T.16.87

ENGINEERING CHANGES ON MODEL 034 CHAIN SAWS (SERIES 1125)

ENGINEERING CHANGES ON MODEL 034 CHAIN SAWS (SERIES 1125)

Engineering Changes on Model 034 Chain Saws (Series 1125)

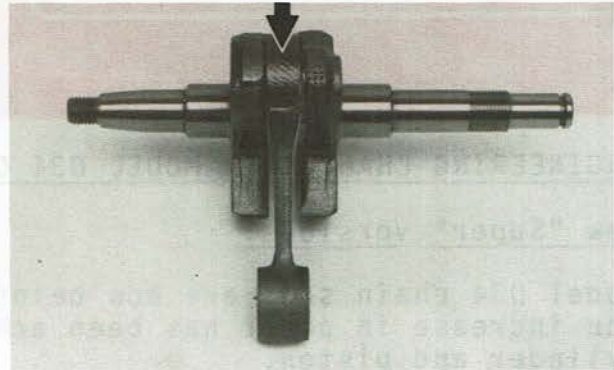
The boost in power for the Super versions has been achieved by increasing the bore from 46 to 48 mm (1.81 to 1.89 in.) and thus upping displacement from 56.4 to 62 cm³ (3.44 to 3.75 cu. in.).

Cylinders with different types of electroplated bores (chrome or Nikasil) are installed on the production line to suit national requirements and operating conditions (intake air loaded with dust, sand etc.). However, only the Nikasil cylinder and piston will be supplied as spares.

Important: The Super cylinder must not be installed in standard-type machines.

New Crankshaft, 1125 030 0401

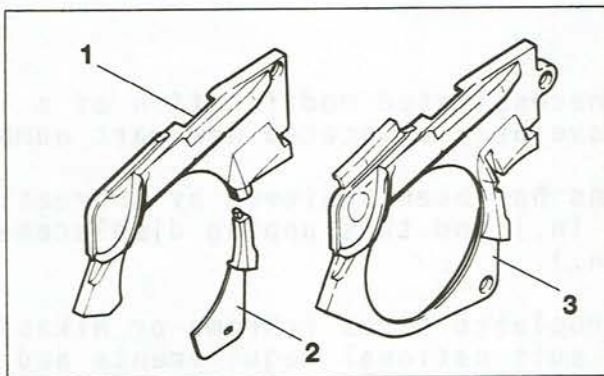
A lighter connecting rod is installed in the new Crankshaft, 1125 030 0401, and comfortably withstands the higher loads in the uprated engine. The new light-weight connecting rod and piston pin mean that the out-of-balance forces in the new engine are much lower.

A steel ring is integrally cast in the new Crankcase, 1125 020 2107, and serves as the seat for the ball bearing at the clutch side. It guarantees that the ball bearing's tight fit is maintained even under extreme operating conditions.

- 1 = Original cover
- 2 = Cover plate
- 3 = New one-part cover

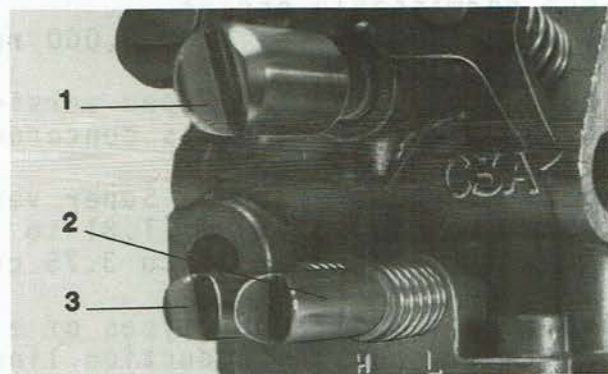
A new, one-part Cover, 1125 021 1101, is used to protect the component parts of the chain brake and the oil pump. In previous versions of the 034, the chain brake and oil pump were protected by a separate cover and cover plate. The new cover can only be used together with the new Crankcase, 1125 020 2107.

- Left: Handlebar with reinforcement plate.
Right: Handlebar without reinforcement plate.

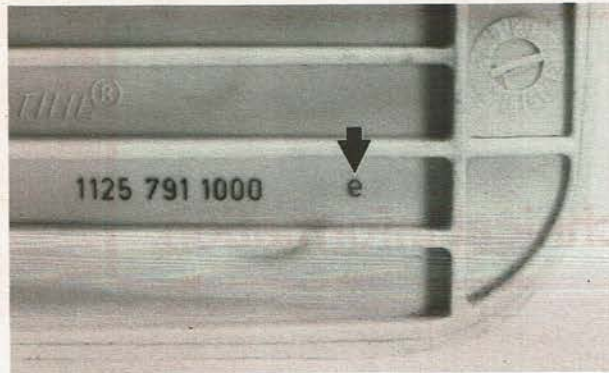
A new modified handlebar will be installed on all versions of the 034. Because of an improved material, we were able to eliminate the reinforcement plate previously used in the upper mounting area. The improved material and section of the new handlebars, in the area of the upper mounting, ensure high durability even under extreme loads.

As the handlebar reinforcement plate is no longer fitted, the mounting holes in the tank housing have been made deeper to take the extra length of the mounting screws. Refer to and observe service note when installing a modified handlebar (without reinforcement plate) in machines with the original-type tank housing.

When installing a handlebar without the reinforcement plate on the original-type tank housing, always fit an A 6.4 washer (9291 021 0140) under the screw heads for the upper handlebar mounting. The wall of the fuel tank could break if the screws are fitted and tightened down without washers.

Left: Original version
Right: New version

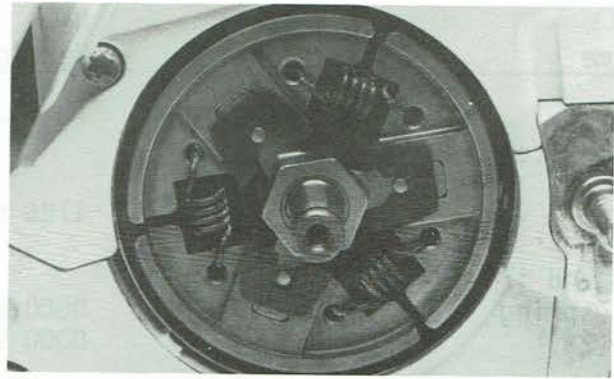
In connection with the introduction of the round rope rotor (see TI.39.86), modified flywheels, with 6 pawl detents, will be installed in place of the previous version with 2 pawl detents. The original and new versions of the flywheel are fully interchangeable, i.e. the part numbers remain unchanged.

- Flywheel, 1125 400 1200, for machines with handle heating from No. X 16 519 610.
- Flywheel, 1125 400 1205, for machines with handle heating from No. X 16 523 021.

Pump piston with helical spring (3) and washers (4)

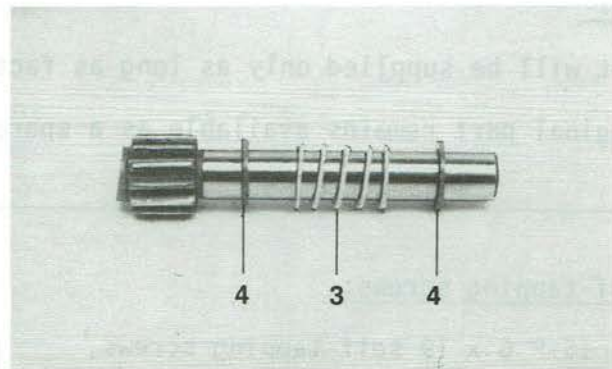
A slightly "softer" helical spring and two washers will be installed from machine No. X 16 786 634 to increase the reliability of the adjustable Oil Pump, 1125 640 3206. The new spring is installed in the same position as the original one, but with a washer at either end. The parts of the original and new version are fully interchangeable in adjustable oil pumps.

Always install the new helical spring with the two washers in the course of repairs to an adjustable oil pump. Never install the washers together with the original helical spring.

Left: Original version
Right: New version

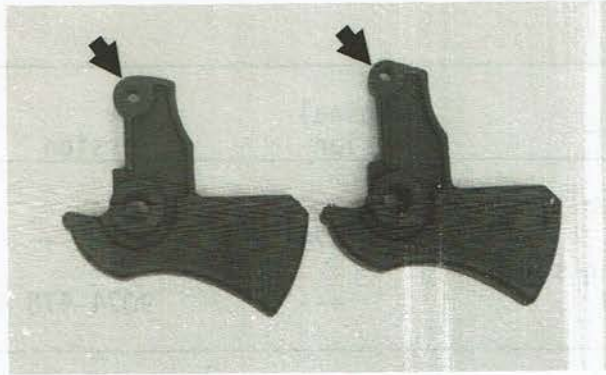
A new throttle trigger, with a modified shape, will be installed from machine No. X 16 782 379 to optimize throttle control. The original and new versions of the throttle trigger are fully interchangeable.

- 1 = Heating Element, 1121 434 5000 (original version)
- 2 = Heating Element, 1121 434 5000 (new version)
- 3 = New Heating Element, 1125 434 5000

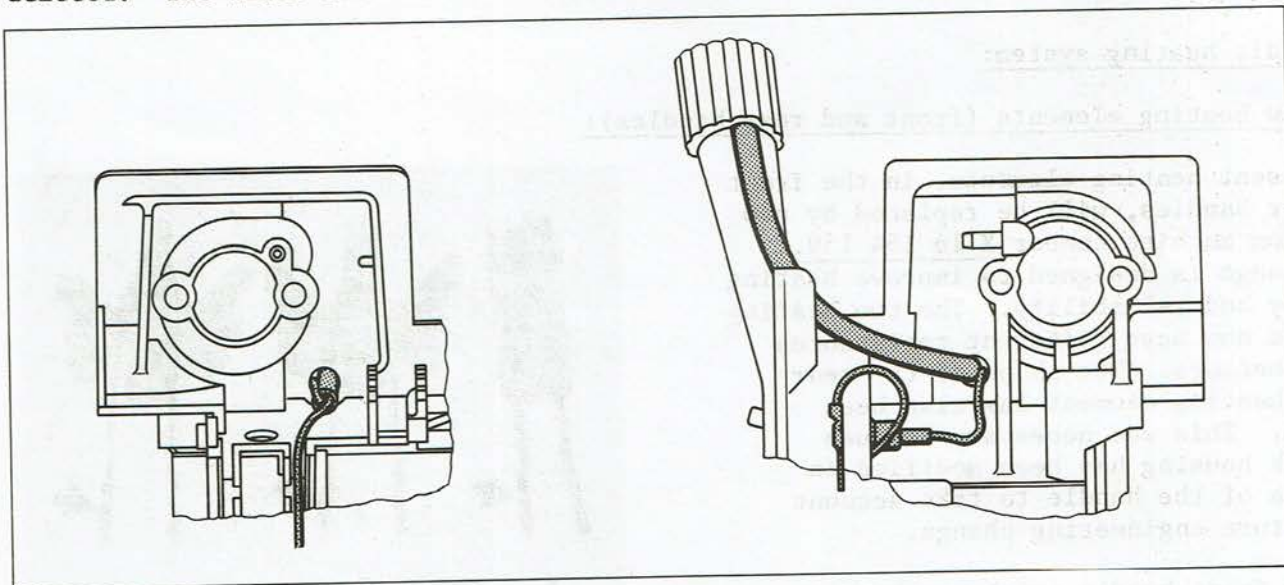
The present heating elements, in the front and rear handles, will be replaced by new ones from machine number X 16 154 159. This change is designed to improve heating capacity and reliability. The two heating elements now have different resistances and connectors. The shape of the rear handle heating element has also been changed. This was necessary because the tank housing has been modified in the area of the handle to take account of a future engineering change.

- Rear handle Heating Element, 1121 434 5000 (original version): rectangular, resistance 0.3 Ohm, with 2 round sockets (1).
- Rear handle Heating Element, 1121 434 5000 (new version): butterfly shape, resistance 0.25 Ohm, with 2 round sockets (2).

- New rear Handle Heating, 1125 434 5000: butterfly shape, resistance 0.25 Ohm, with 1 round socket and 1 round pin (3).
- Front handle with Heating Element (original version): resistance 2.2 Ohm, with 1 contact sleeve (for switch) and 1 round pin.
- Front handle with Heating Element (new version): resistance 1.6 Ohm, with 1 contact sleeve (for switch) and 1 round pin.

Rectangular heating element bonded at an angle.

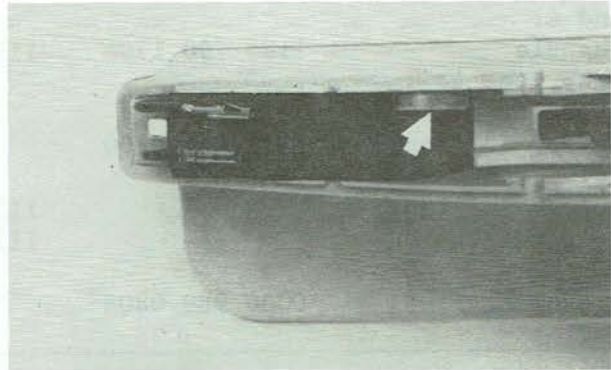
Original-type rear handle Heating Element, 1121 434 5000 (rectangular), can still be used in conjunction with the original front handles (heating element $R = 2.2 \text{ Ohm}$), even on modified tank housings, if they are bonded in position at an angle as shown in the illustration.

The expanded rubber Thrust Pad, 1121 791 9000, must be cut as shown to ensure that it can be fitted without being obstructed by the new lug on the rear handle.

Important note: When bonding the rear handle heating element in position, make sure that the surface in the tank housing is completely free of grease. The whole area of the heating element must lie perfectly flat and crease-free.

Left: Original washer (flat)
Center: New washer (interim version with lip).
Right: New washer (future version with warts).

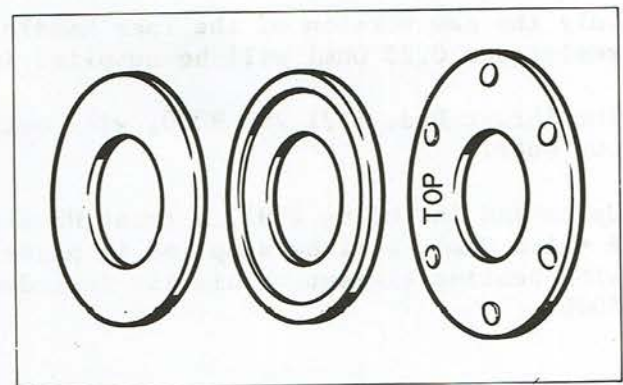
A new thrust washer will be fitted in place of the present one between the chain sprocket and E-clip. For an interim period, the new washer will have a lip on its circumference, but this will be replaced in the foreseeable future by 6 warts.

This retaining action is naturally effective when the E-clip has to be removed in service. If the E-clip butts against the warts of the thrust washer during removal, insert a thin screwdriver between the E-clip and washer and slip the E-clip over the warts.

Spring, 1125 647 2400
Left: Original version
Right: New version

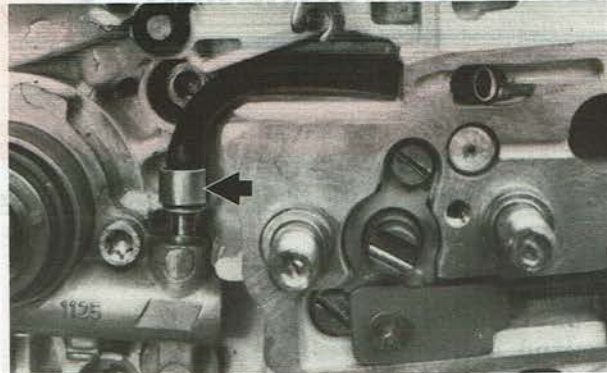
The ring of the Drive Spring, 1125 647 2400, has been stiffened. This ensures dependable operation of the oil pump even if pressure is increased by a blocked oil inlet hole in the guide bar.

The new springs can be identified by the dark blue coloring which results from the heat treatment (temper color). The original springs are metallic gray.
